Public Meeting on Oklo Topical Reports

September 1, 2021

Maximum Credible Accident Topical Report

Performance-based Licensing Topical Report

4.4 Classifying functions and features

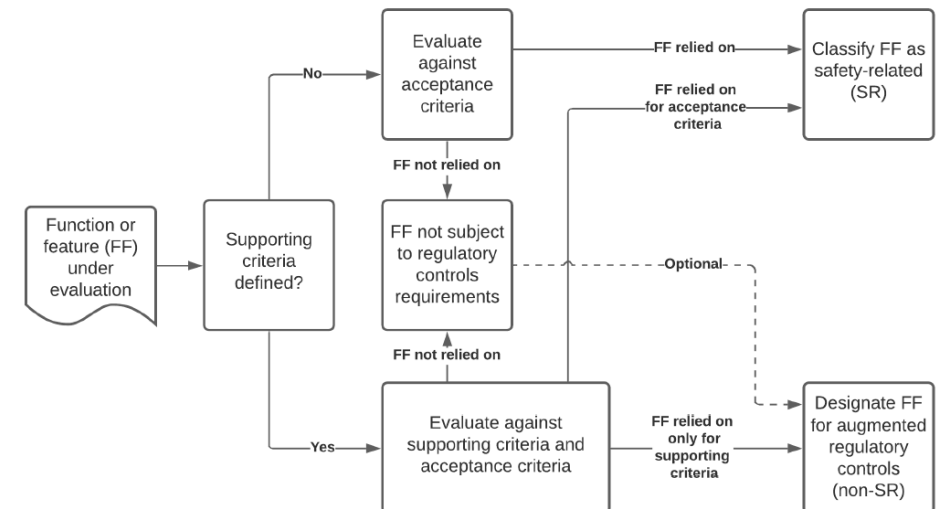
C. The PBLM TR does not address the regulatory requirement under 10 CFR 50.34(f)(3) that the application provide sufficient information to demonstrate that the quality assurance list required by Criterion II, Appendix B, 10 CFR Part 50 includes all structures, systems, and components (SSCs) important to safety.

- Section 4.4, provides for a systematic approach to classifying functions and features.

The methodology identifies the safety relevance of each function and feature of the design as it contributes to the licensing basis event analysis. To make this determination, each function and feature is evaluated individually to determine whether the function or feature is relied on to meet the acceptance criteria and supporting criteria (if defined). Figure 4-1 schematically shows the evaluation process for functions and features described in the following sections.
